**GS# 210-068 NEW ADMINISTRATION BUILDING PHASE II**

**Mississippi Delta Community College**

### Addendum No. 3

**SINGLE LINE DIAGRAM**  
NO SCALE

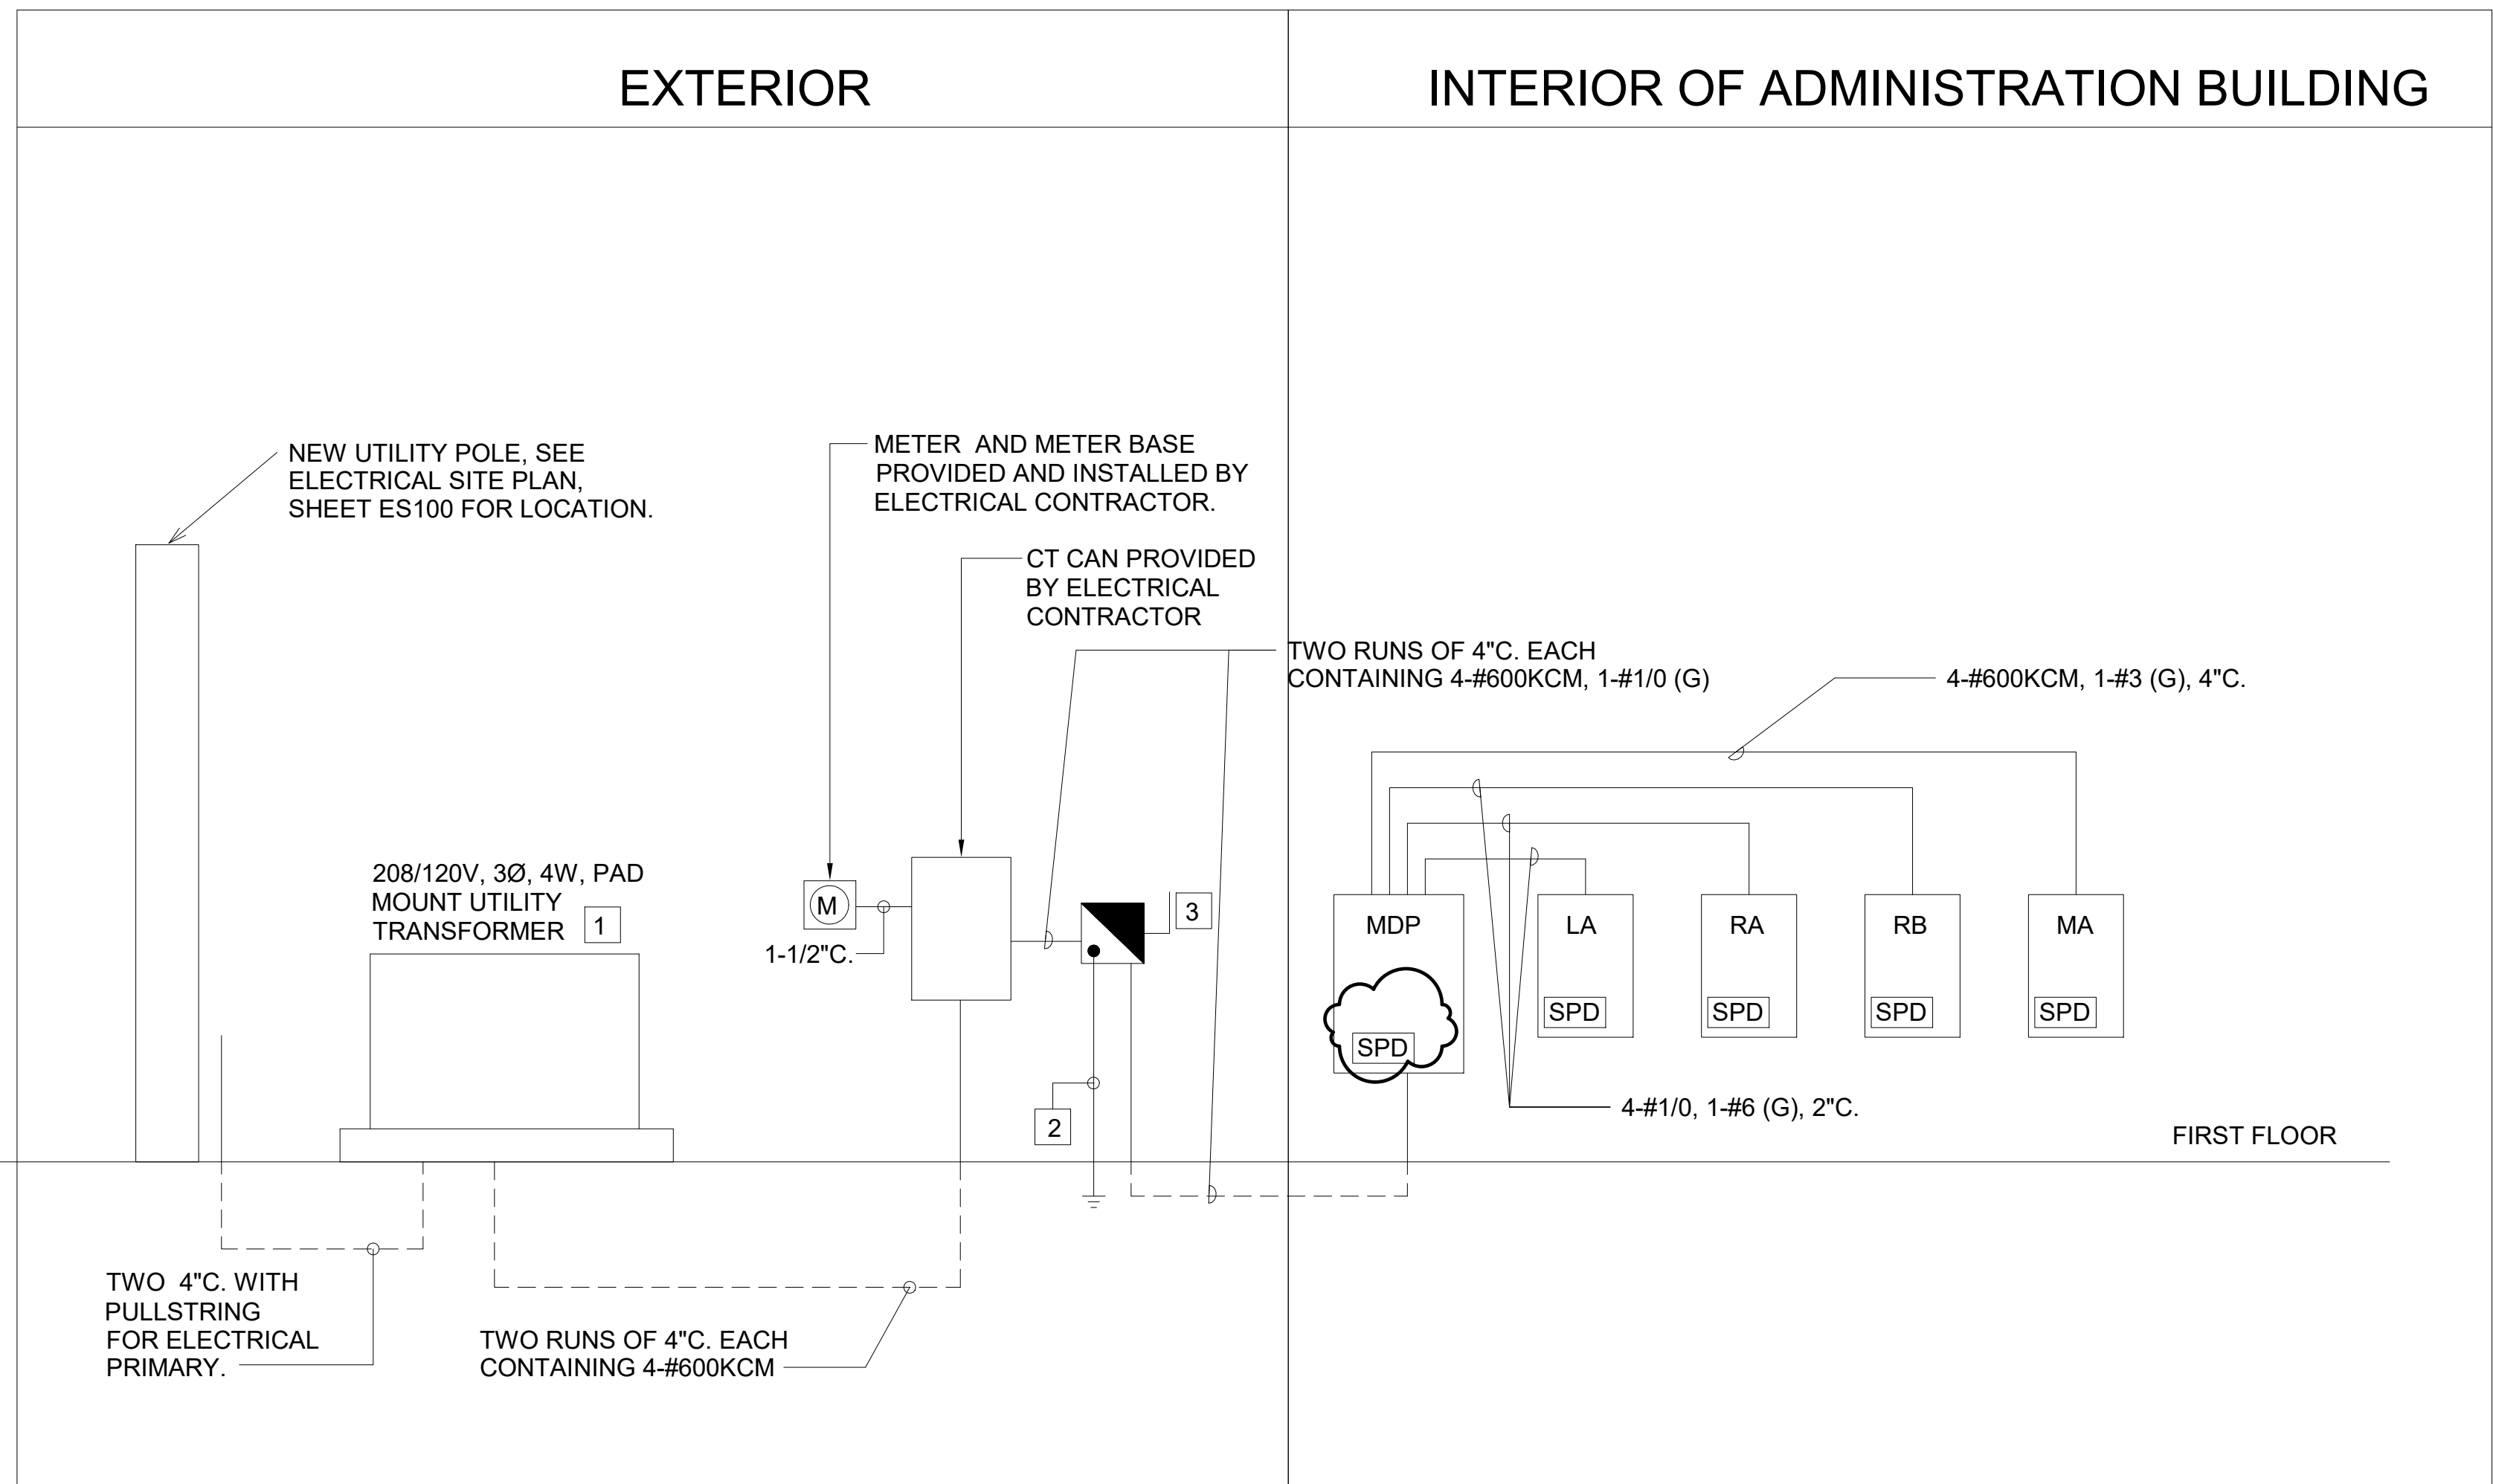
- a. Section 01900 Division One Supplement:
  - i. 2.01 Schedule of Allowances – **Revise** Paragraph B: "Include in the Bid, for inclusion in the Contract Sum, the amount of \$50,000 for Utility Fees. See Sheet E003.

- a. Sheet E003: Added an allowance for utility fees. Provided description of SPD devices.
- b. Sheet E201: Added sheet showing mechanical connection locations.

- A. COORDINATE ALL UTILITY COMPANY REQUIREMENTS WITH ENTERGY. COMPLY WITH ALL UTILITY COMPANY REQUIREMENTS EVEN IF DIFFERENT THAN SHOWN ON THIS SHEET. AT LEAST 10 DAYS PRIOR TO BID, NOTIFY THE ENGINEER OF ANY DISCREPANCIES. PAY ALL UTILITY COMPANY CHARGES. CONTRACTOR SHALL INCLUDE AN ALLOWANCE OF \$50,000 TO COVER ENGERGY COSTS ONLY. UNUSED FUNDS WILL BE RETURNED TO THE OWNER.

- C. SEE PANELBOARD SCHEDULES FOR PANELBOARD INFORMATION.
- D. SEE SPD DEVICES MAY BE INTERNAL OR EXTERNAL AT THE CONTRACTOR'S DISCRETION PROVIDED SPACE IS AVAILABLE. ALL SPD'S SHALL BE RATED AT 200kA PER PHASE MINIMUM. CONNECT SPD DEVICES TO PANELS IN ACCORDANCE WITH MANUFACTURERS RECOMMENDED WIRE AND BREAKER (WHERE REQUIRED) SIZING.
